Access Compliance Report

Public Rights-of-Way

(Curb Ramps)

Intersection ID: 14846	Main Street: HENLEY_PL	Cross Street: S_KINGS_DR	Location: NE
ADA ID: 5CE7C48BE947	Ramp Type: Perp	Initial Pass/Fail: Fail	Overall Compliance: No
Severity Score: 13.75			
Codes/Mitigation Info/Possible Solution		Field Measurements/Component Compliance

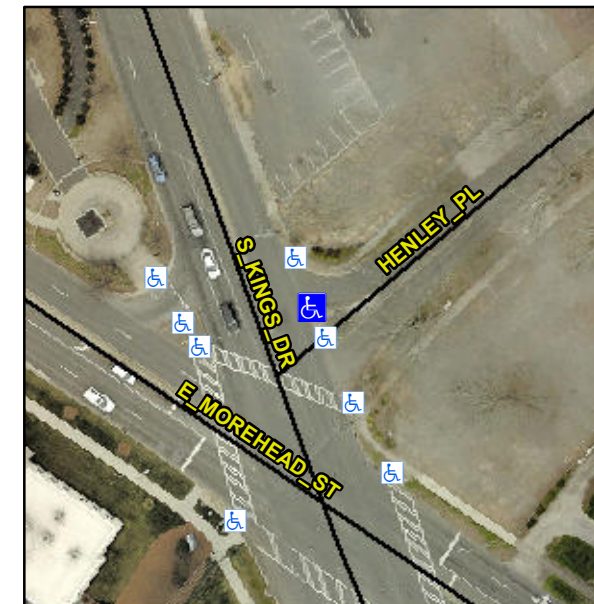
R304.2.2, R304.5.3

Compliance	Description	Data	Compliance	Description	Data
N/A	Ramp Length (in)	48.0	No	Ramp Slope (%)	8.4
Yes	Ramp Width (in)	48.0	No	Ramp XSlope (%)	4.2
N/A	Flare Type LT	N/A	N/A	Flare Type RT	N/A
N/A	Flare Slope LT (%)	N/A	N/A	Flare Slope RT (%)	N/A
N/A	Flare Traversable LT?	N/A	N/A	Flare Traversable RT?	N/A
N/A	Landing Length (in)	N/A	N/A	DWS Provided?	N/A
N/A	Landing Width (in)	N/A	N/A	DWS Contrast?	N/A
N/A	Landing Slope (%)	N/A	N/A	DWS Length (in)	N/A
N/A	Landing X Slope (%)	N/A	N/A	DWS Full Width?	N/A
N/A	Landing Curb? (Y/N)	N/A	N/A	DWS Offset (in)	N/A
N/A	Shared Landing?	N/A			
N/A	Gutter Ponding?	N/A	N/A	Gutter Slope (%)	N/A
N/A	Gutter Lip Ht (in)	N/A	N/A	Gutter X Slope (%)	N/A
N/A	Painted X Walk1?	No	N/A	Painted X Walk2?	N/A
	X Walk 1 Direction	To N		X Walk 2 Direction	N/A
N/A	X Walk 1 Width (in)	N/A	N/A	X Walk 2 Width (in)	N/A
	X Walk 1 Slope (%)	0.0		X Walk 2 Slope (%)	N/A
	X Walk 1 X Slope (%)	3.7		X Walk 2 X Slope (%)	N/A

Remove & Replace Entire Ramp.
